**ISSUE:** Certificate of Appropriateness for alterations

**APPLICANT:** Taco Bell of America represented by Joanie Godsey, Architect

**LOCATION:** Old and Historic Alexandria District  
417 King Street

**BAR#2025-00021 - OHAD**  
**417 King Street**

**A4.0**

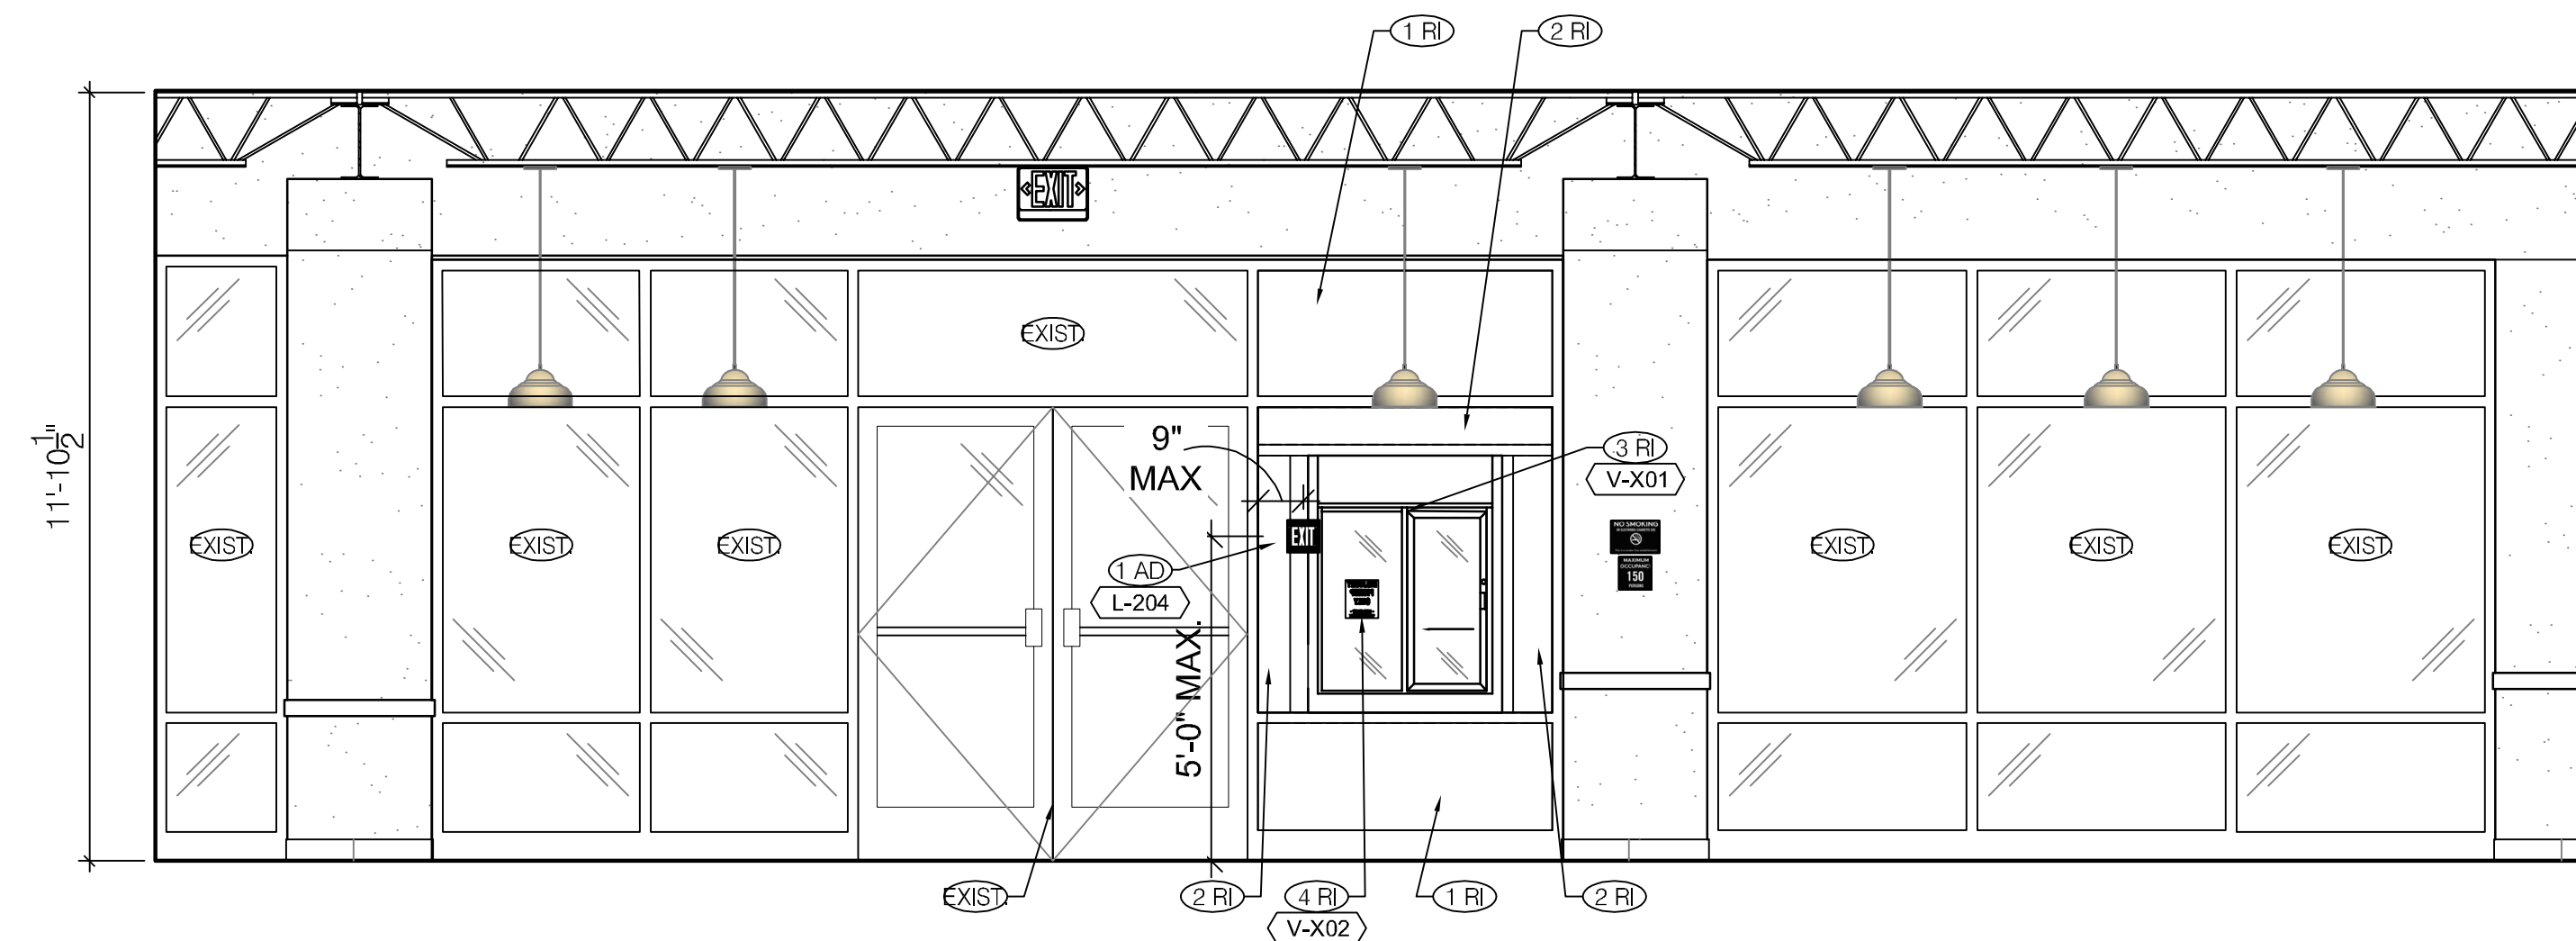
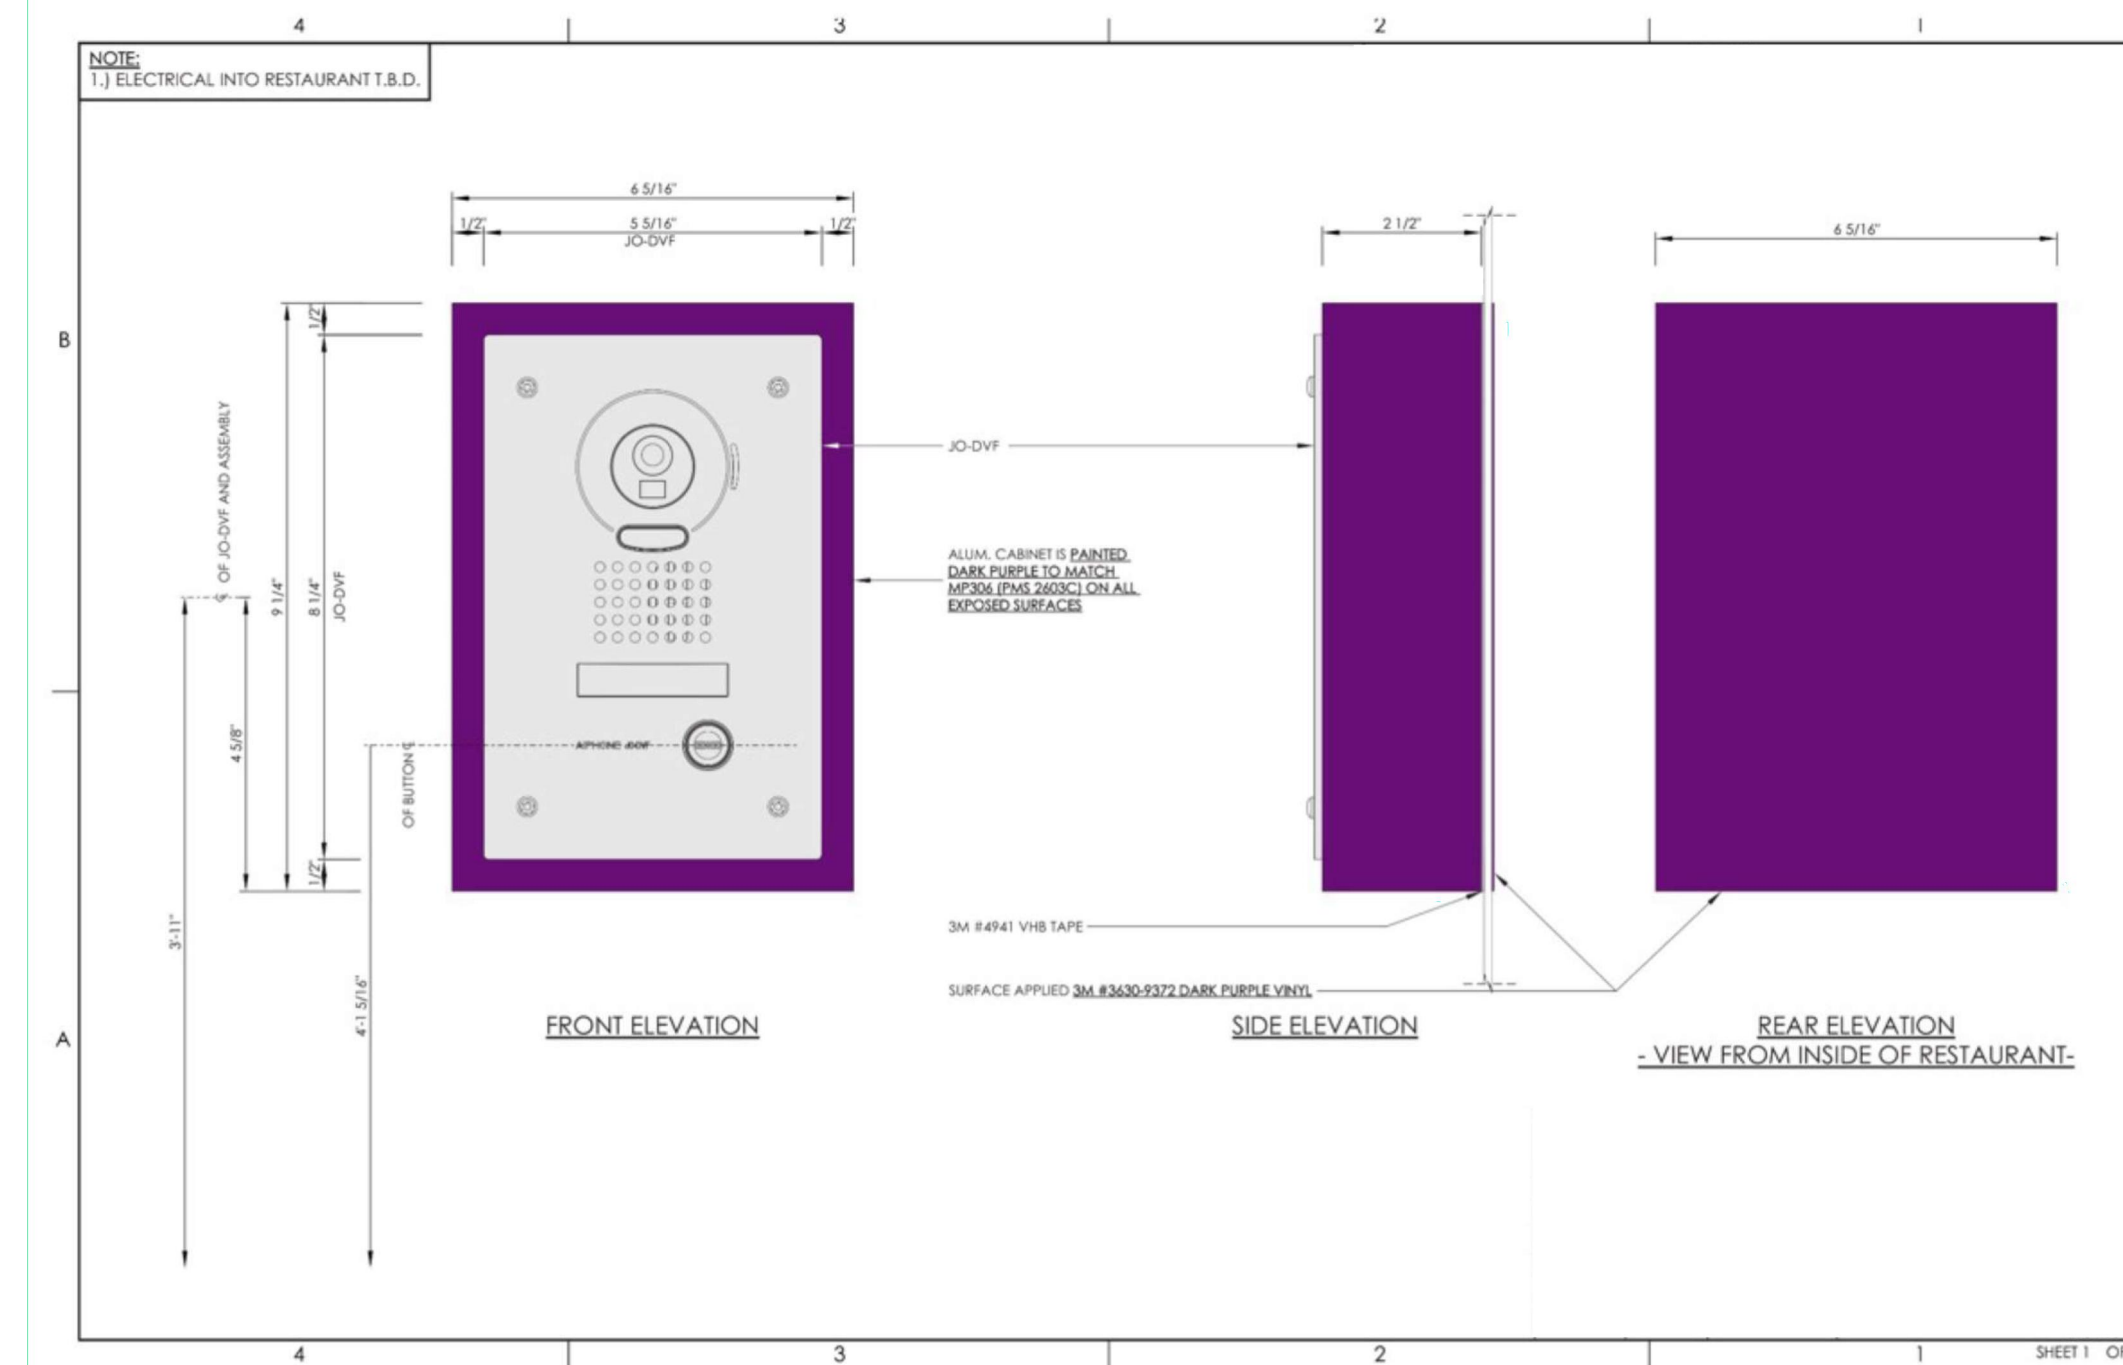
The applicant proposes to paint the fabricated aluminum cabinet surrounding the pickup window a vibrant shade of purple. The selected shade is too intense and isn't harmonious with the existing signage. For reference, below is a photo of a recently installed pickup window at the upcoming 14<sup>th</sup> and U St., NW Taco Bell Cantina in Washington, DC. Staff recommend that the color of the proposed pickup window matches the existing signage and storefront. The applicant should work with staff to update the colors before applying for a building permit.

Staff recommends approval of the Certificate of Appropriateness for alterations with the condition that applicant work with staff to update the colors of the pickup window before applying for a building permit.
